# Technical Service Information

## THM 4L80-E NEW FORCE MOTOR AND ELECTRONICS FOR 1994

**FORCE MOTOR (PRESSURE CONTROL SOLENOID)  
1994-UP MODELS ONLY!**

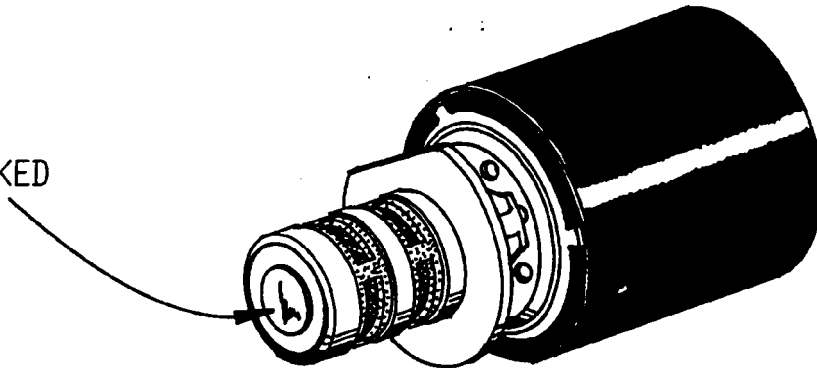
(1) **FORCE MOTOR** - New design that does not require torque signal oil be sent back to the end of the enclosed spool valve, so the feed passage and the screen in the end of it were eliminated, as shown in Figure 1. The armature housing is also smaller in diameter than the previous force motor, and is now Black in color (See Figure 1).

SCREEN IN FEED PASSAGE

PASSAGE BLOCKED

## THM 4L80-E SPACER PLATE

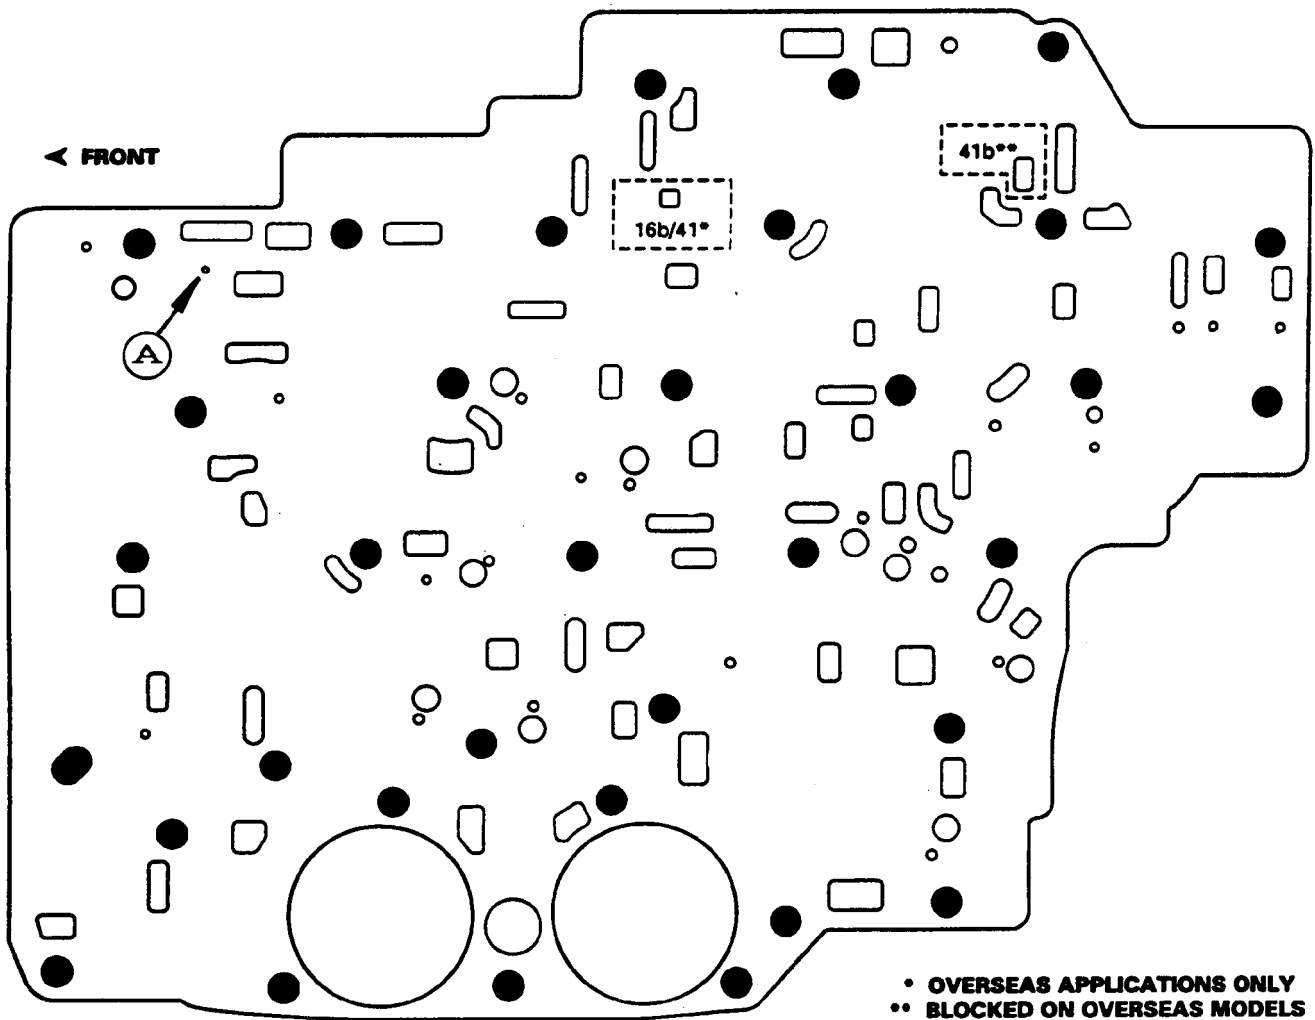
(2) **SPACER PLATE** - The orificed feed hole for torque signal oil in the spacer plate, marked "A" in Figure 2, has been eliminated to accommodate the new design force motor (See Figure 2).

HOLE MARKED "A" ELIMINATED IN THE 1994 MODEL SPACER PLATE.

Figure 3

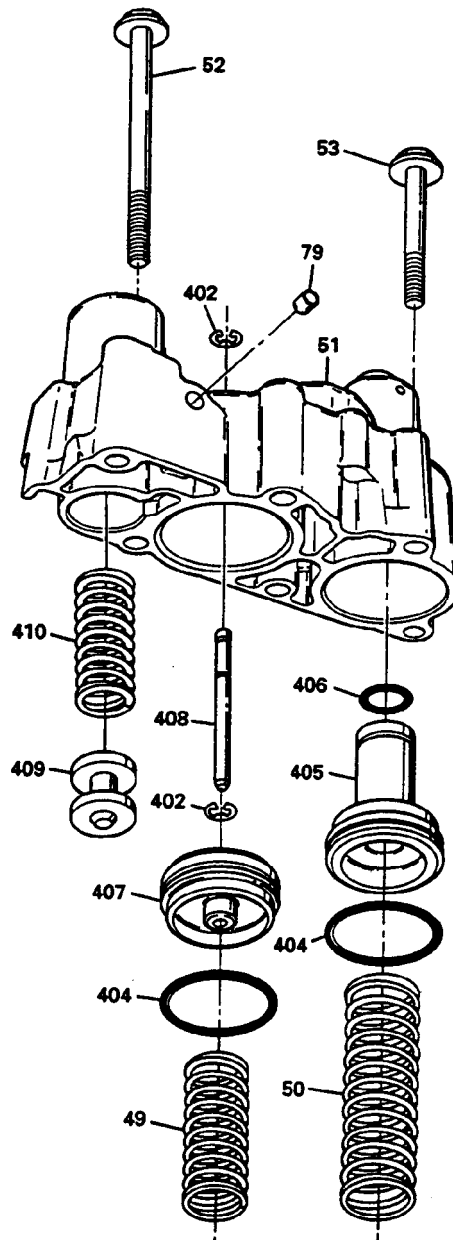
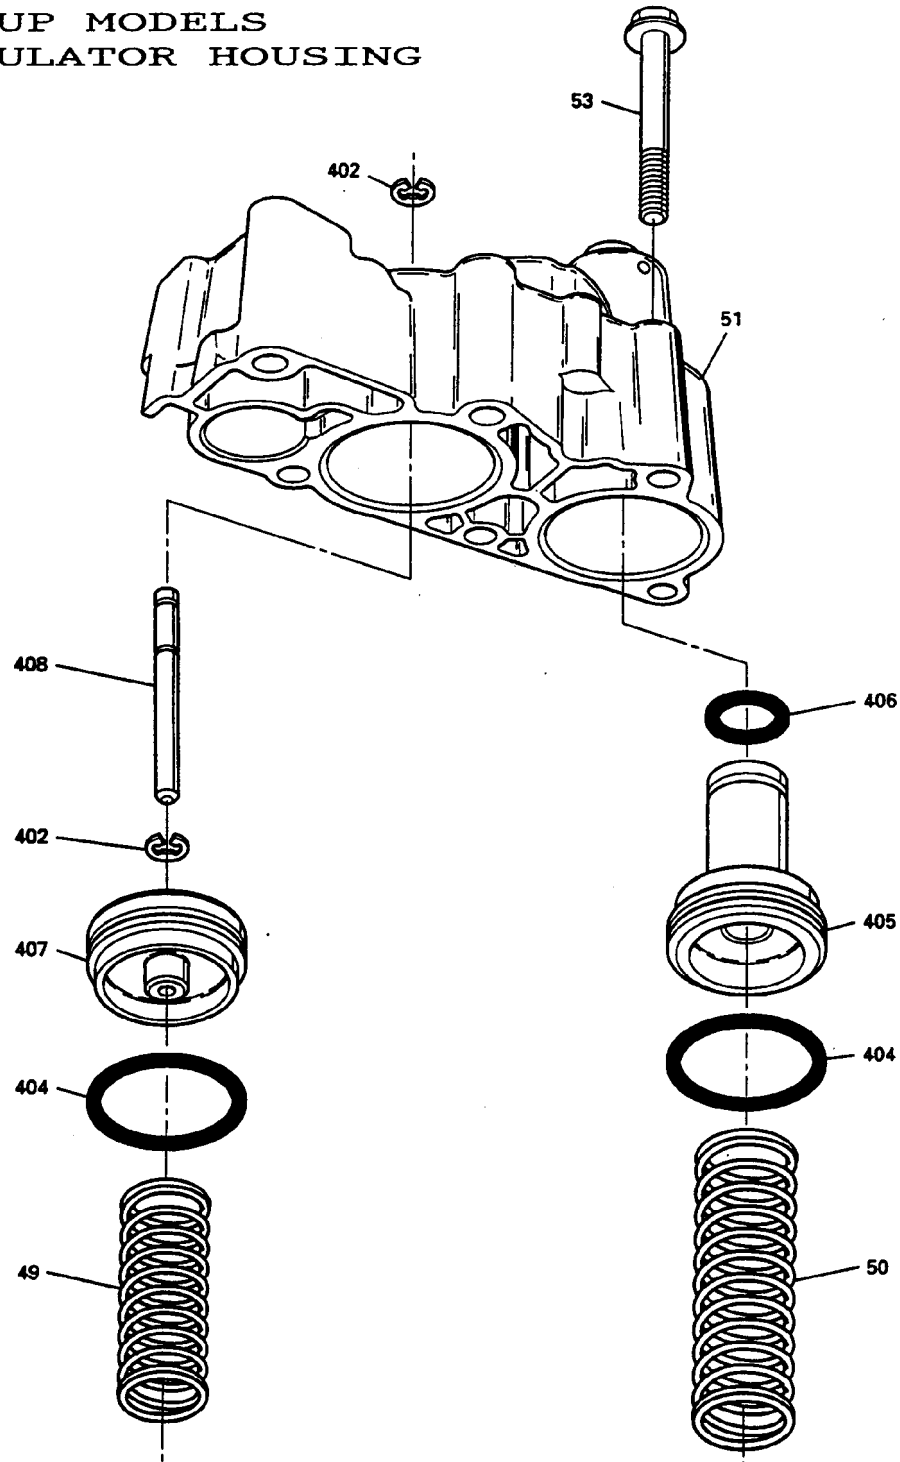
(3) **TORQUE SIGNAL COMPENSATOR VALVE** - Eliminated because it is no longer needed to absorb torque signal pulses created by the previous model PCM. The torque signal feed passage is no longer drilled in the accumulator housing on 1994 models (See Figures 3 and 4)
